CHANGE NOTIFICATION

PCN# 042314

Subject: Notification of Additional Assembly Location, ASE Korea for LTM4601

Country of Origin on Top Mark

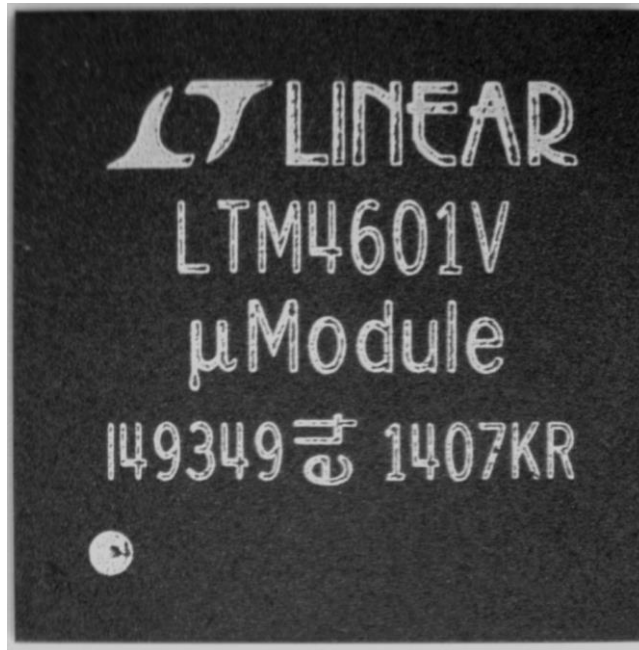
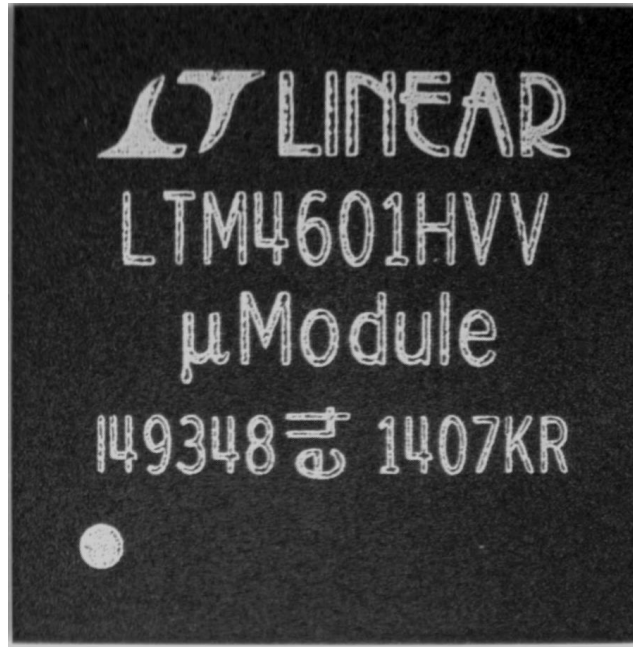
Please be advised that Linear Technology has successfully qualified ASE Korea as an assembly site for the subject packages. It was desirable to qualify ASE Korea to serve as an alternate source since it is located in a different geographic area than our existing assembly location in Penang, Malaysia. ASE Korea is ISO9002, QS9000, ISO14001, TS16949, OHSAS 18001 and QC80000 certified. A summary of ASE Korea's product mix and LTC's qualification results are shown on the attached pages. The facility passed a site audit by LTC's supplier quality organization. LTC product assembled in ASE Korea can be identified by the country of origin marked on the device as "KR". The product photos showing the ASE Korea marking are attached. The datecode of the first units assembled by ASE Korea will be approximately 1407. The list of affected part numbers is presented below in the table.
